2020-01-29 JVA: Design Change Notification:
 Ultimo 2020 the clamp screw hole will be on same side as connector and have diameter 8mm.

www.jvl.dk		JVL A/S Bregnerødvej 127 DK-3460 Birkerød Tel: +45 4582 4440 Email: jvl@jvl.dk		File name: MAB23x-31_V1.2 Part no. MAB23x-31	
		Description Brake 24V for NEMA23 ID6.35/OD10 M8 1.5Nm			
Drw	JVA + 12	Date	2020-06-09	Unit	mm
App	PCR + 12	Date	2020-06-09	Scale	1:1
ERP	JVA + 12	Date	2020-06-09	 A4	Tolerances Unless Specified
					Linear: 0.5-6 ±0.1 6-30 ±0.2 >30 ±2% Angles: ±3°

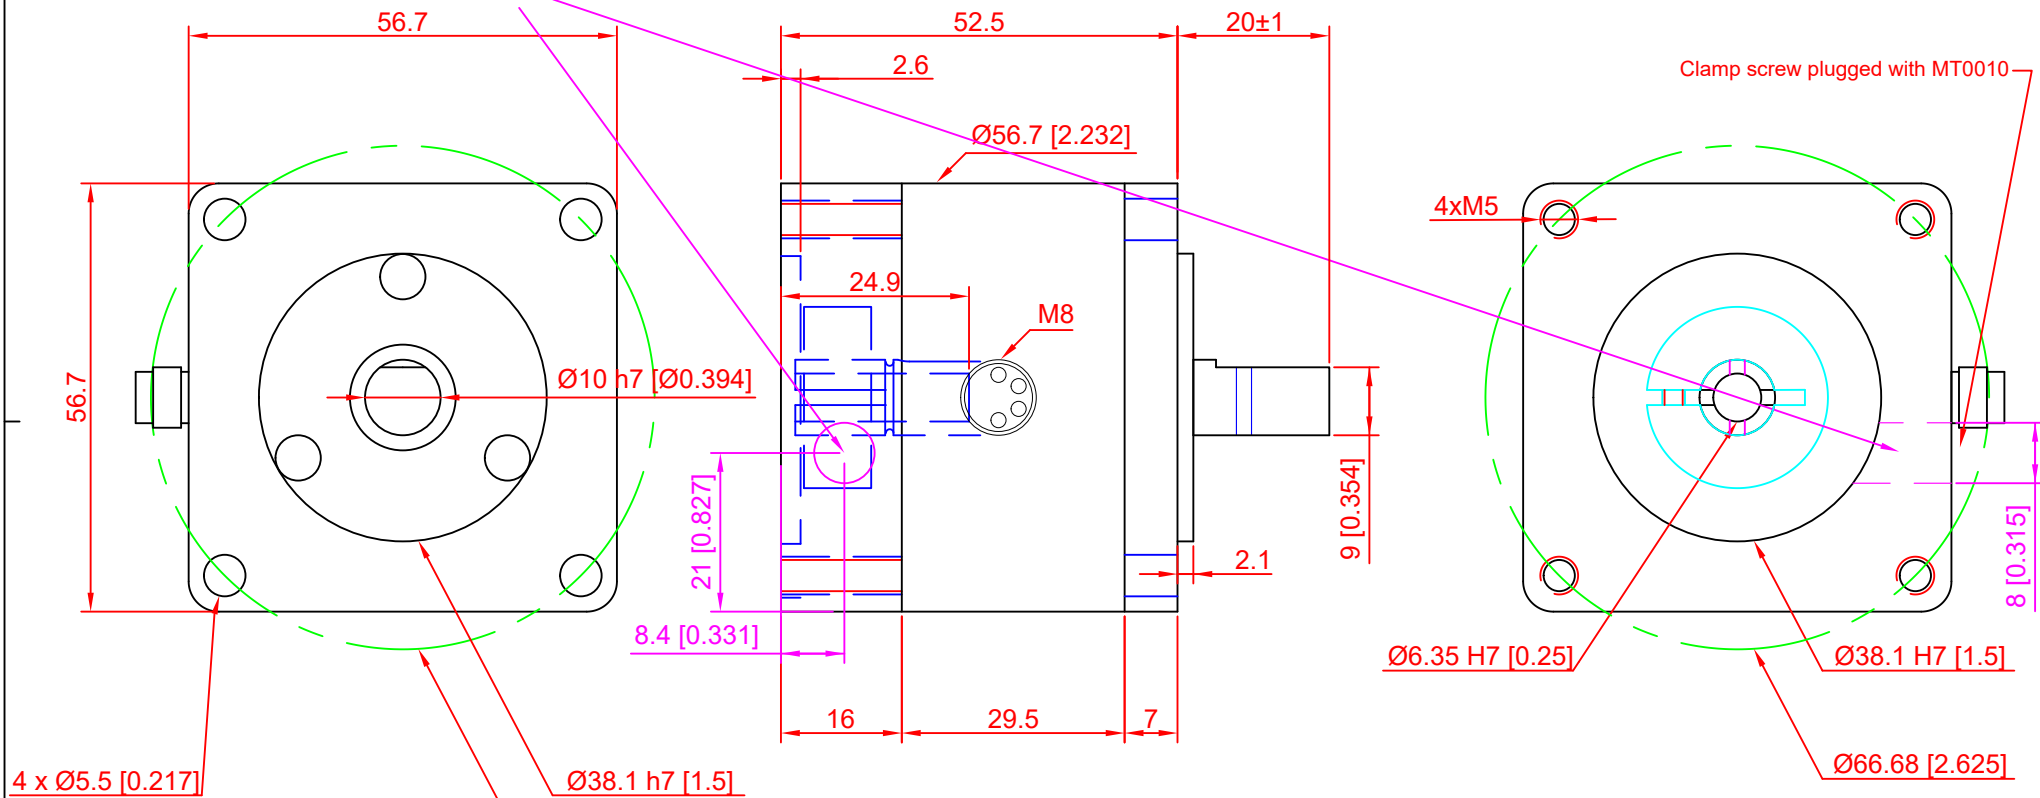
Revision	Note	Date + init
1.0	First Edition	2014-10-09 PCR
1.1	New Template, hole moved for clamp screw, other minor adjustments.	2020-01-29 JVA
1.2	4 slots in shaft. Specified transfer Torque	2020-06-09 JVA

Shaft Collar Screw Torque (M3): 2Nm
 Max transfer torque: 2.8Nm
 Brake torque: 1.5Nm
